Interactive comment on “Hydrology of inland tropical lowlands: the Kapuas and Mahakam wetlands” by H. Hidayat et al.

H. Hidayat et al.

Received and published: 25 November 2016

Fig. 1. Fig. 1. HEC-RAS simulated discharges for different cross sections in the downstream Kapuas River (left) and the upstream Kapuas River (right) of the modelled river section.

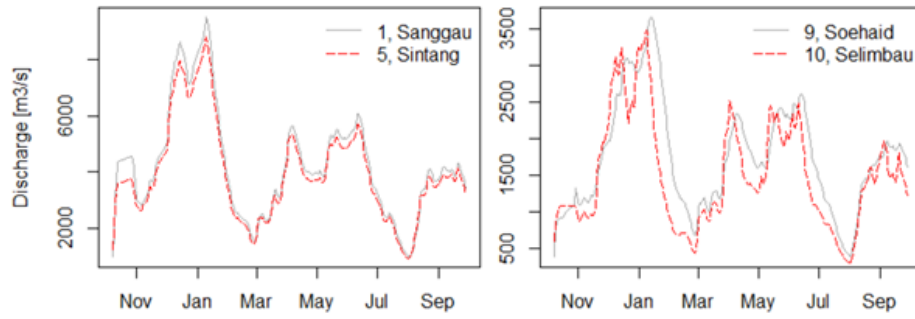
5. P5, L7-9: The Authors reported that due to the global circulation and the regional climate the central and northern parts of Kalimantan have bimodal rainfall patterns with two peaks of rainfall. Those peaks generally occur in October through November and March through April. Is this consistent with the results of the HEC-RAS model shown in Figure 8 which presented the timing of rising and falling limbs?

Reply: Yes, our HEC-RAS simulation reflects this bimodality of the rainfall pattern in the study area, as shown in the simulated discharge (Fig. 1).
